Ref: SSD-81623209- MOD3

**RE: SUBMISSION TO SSD-81623209-MOD3 AT 9-21 BEACONSFIELD PARADE,
LINDFIELD**

Thank you for the opportunity to comment on State Significant Development (SSD) application (SSD81623209-MOD3 for the Design Refinements) at 9-21 Beaconsfield Parade, Lindfield.

Image 1: FO carting paths for residents – across traffic areas.

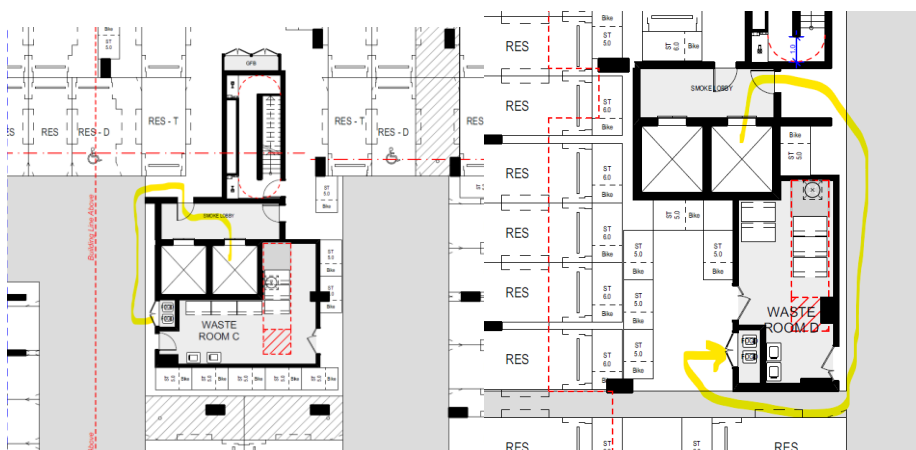
- a) Six FO rooms have been provided in Basement 1. This is considered an inappropriate FO collection method as residents are highly unlikely to walk to the basement to use the FO bins when there is a chute and bin system on each floor.
- b) Some FO carting paths for residents to the FO bins from the lifts is along the traffic aisle of the basement.

A bin room on each floor needs to be provided, which includes a FO bin, yellow lid, blue lid and chute. This room is to be mechanically ventilated and drain to sewer. The manager will be responsible for collecting the bins from each floor and decanting them into larger bins in the bin holding room.

Image 2 – loading dock area

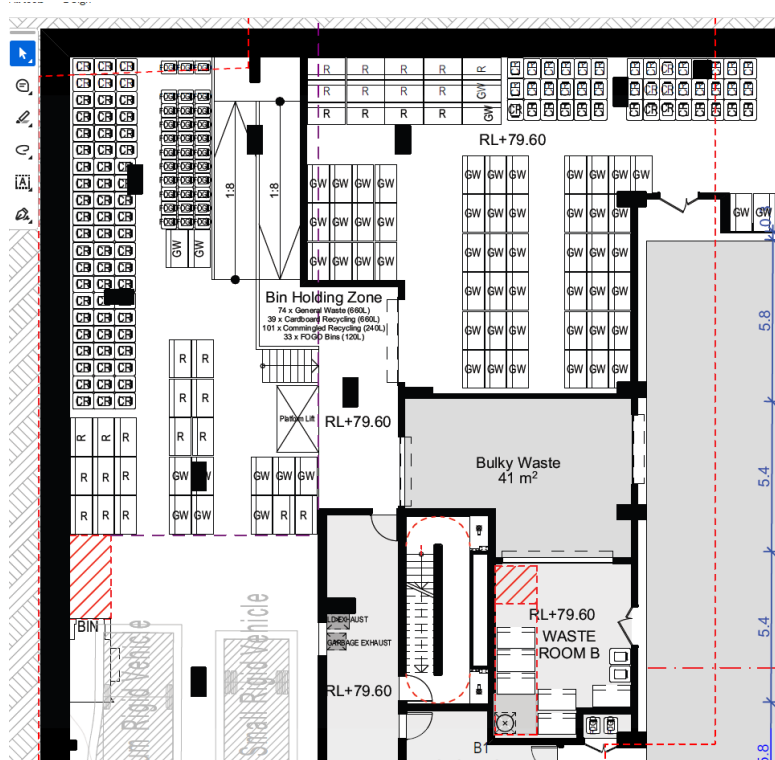
- a) The loading bay as access and space for a MRV and SRV.
- b) The bin holding area is too congested and bins are triple stacked. A collection vehicle for one type of bin will not be able to access all the required bin in this layout.
- c) Bins are stored between two levels of the basement, with a ramp or platform lift. This is considered an inefficient and unacceptable storage solution. All bins and storage areas need to be at loading dock level. The collection crew will not be moving bins between the two levels.

- a) Confirm sufficient access for HRV waste vehicle and safe access for the collection crew.
- b) Confirm loading location for bulky waste. Confirm how the waste will get from the storage room to loading dock. It is not appropriate to be at different levels.
- c) A Loading Dock Management Plan is to be designed and implemented including booking priority access times for residential waste vehicles (**Note:** there will be up to 8 collection vehicles per week for residential waste.)
- d) All carting paths need to be shown on the plan for the manager to move bins from each bin room to the storage room.
- e) A cart and trailer will need to be provided along with a storage space to park the equipment.
- f) A bin lifter will need to be provided.

Image 3: Turn area for waste truck

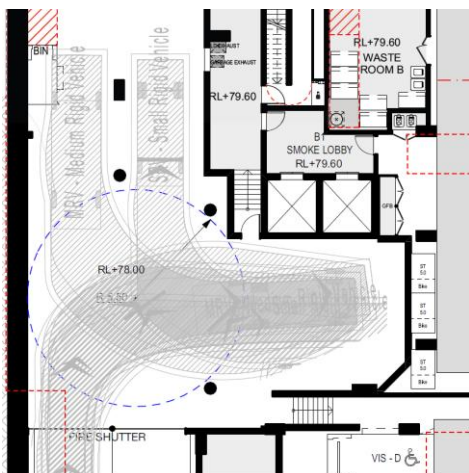
- Finished ceiling to floor height clearance of 4.5m is required for waste vehicle. The clearance height includes space for lights, fire system, cable trays etc. for both waste loading dock and delivery dock. Image 4 seems to illustrate this.
- Turn templates need to be provided to ensure clearance for the waste loading dock

- Confirmation of HRV access as per AS2890.2 needs to be provided
- Confirmation of turn template needs to be provided for the waste HRV vehicle entrance and exit for the site.

Image 6: Bin infrastructure on each floor

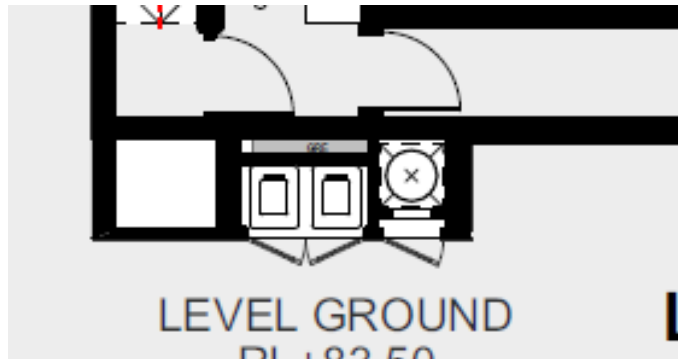
- d) On top of this, three days capacity needs to be provided within in each bin room on each floor, this is in case the building manager is away or a long weekends/ public holidays.

- a) Redesign all waste bins and chute to be in a room on each floor.
- b) FO collection is to occur on each level in each bin room

Image 7: Chute rooms

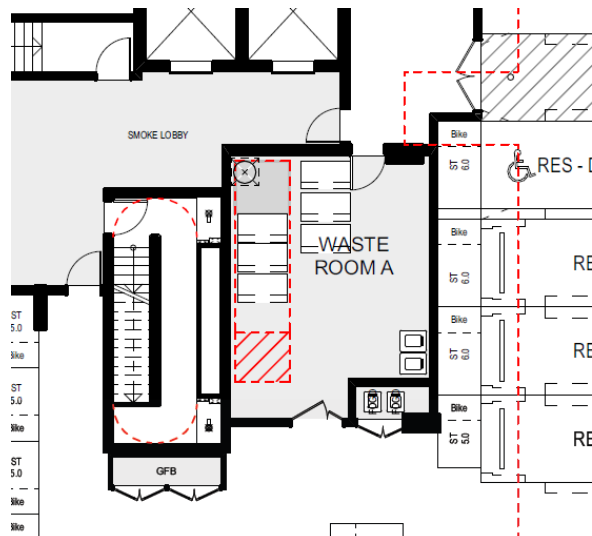
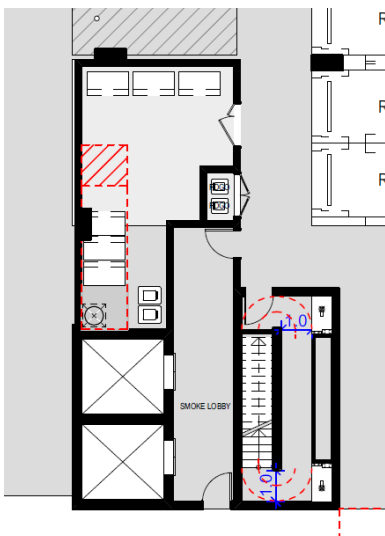
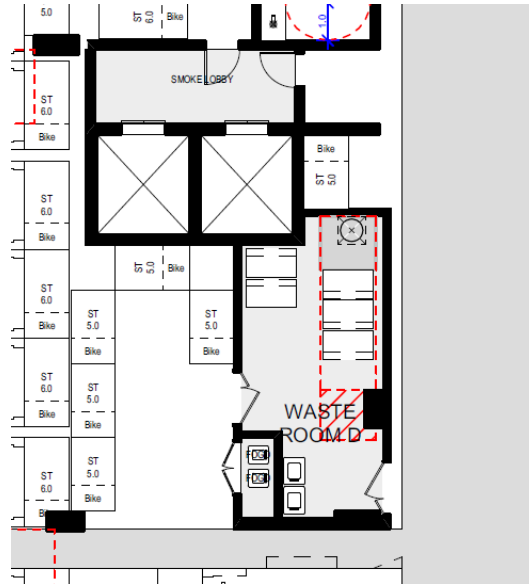
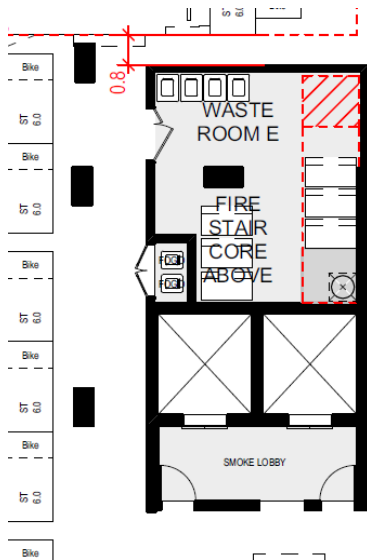
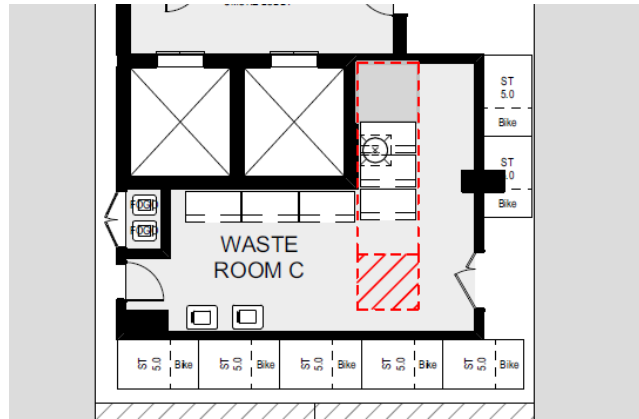
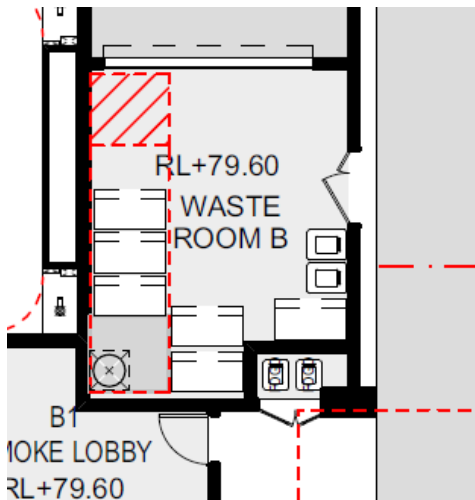
- a) 6 chute rooms are provided across the basement level.
- b) 660L bins are proposed. Council proposes to upsize these to 1100L bins to reduce the number of bins required on site.
- c) It is unclear regarding the proposed chute system. A linear system will be required to automatically move bins under the chute. There needs to be 3 days capacity under the chute. It is unclear the layout of this system as currently show it is incorrect and will not work for most of the chute rooms e.g. A, B, D, E & F

- a) Ensure there is mechanical bin changing system under each chute.
- b) Amend the chute rooms to allow linneras to automatically move bins along. Note: there needs to be space on either side the chute for bins to move under it.
- c) Provide carting path maps from the chute rooms to the bin storage room.
- d) Remove separate FO bin rooms.

Image 9: Bin holding area

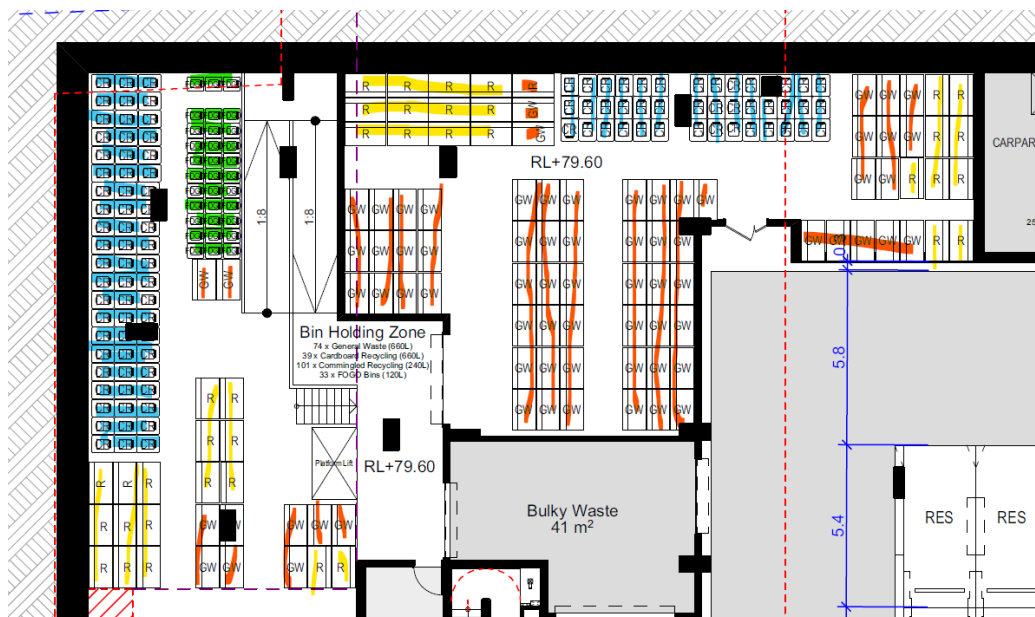
- a) Residential waste holding room will need to hold
 - i. 22 x 1100L waste bins
 - ii. 19 x 660L yellow container recycling bins
 - iii. 19 x 660L blue paper bins
 - iv. 21 x 240L FO bins

- b) Council will consider these larger compactor bins (image 8) to service all residential waste across the site. Note height reequipments for this size bin.
- c) The layout of this area is too complicated for the building manager and collection crew and will involve too much time in moving bins. A more efficient layout needs to be considered e.g. all same type of bin is kept together and accessible easily by the collection crew without having to hunt through the area for all bins.

- a) Redesign / resize for new bin sizes and bin numbers.
- b) Ensure area is at one level
- c) Confirm where the pylons are within the basement area, especially the waste areas.

Image 10: bulky waste storage.

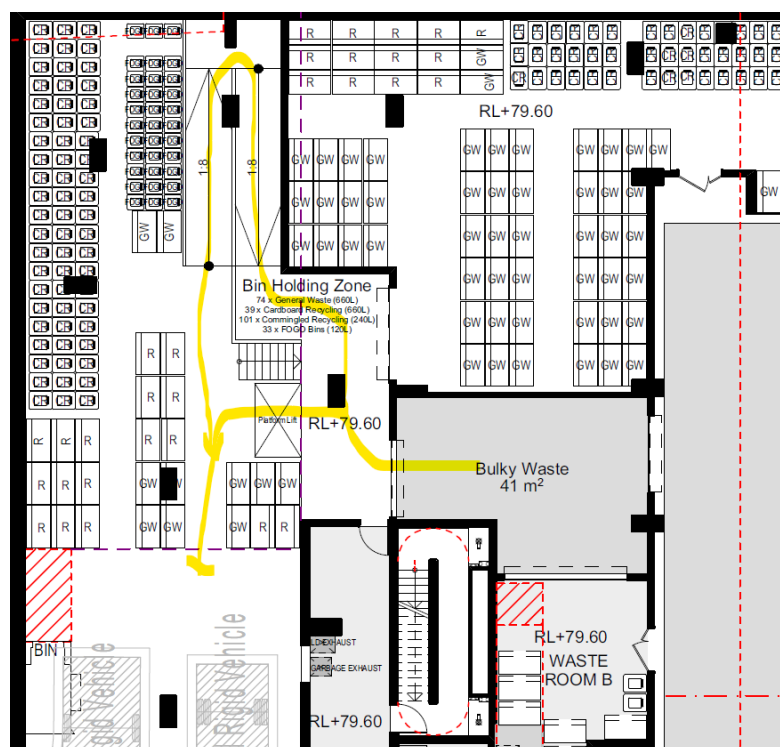
- a) There is insufficient bulky waste holding area. The room is 41m² and should be 49.3m².
- b) Concerns are raised over the required size of the room and ability for management to keep it in a tidy and safe manor.
- c) The ramp carting option is over (30m?), and a cart and tug will need to move the material this distance and be able to access the ramp.

- a) It must be demonstrated how the building manager will move the bulky waste from the room to the collection location in a safe manner. It is inappropriate via the platform lift due to time and WHS considerations. If the ramp is used, it needs to be demonstrated how a cart and trailer will fit.
- b) A bin tug and cart need to be provided for the manager to cart the items
- c) Information needs to be provided on how the residents will deliver the items safely to the bulky waste room or where the collection points for management to pick it up from, are located. It is suggested a space is allocated near each lift for residents to leave their items and management move them to the bulky waste room.
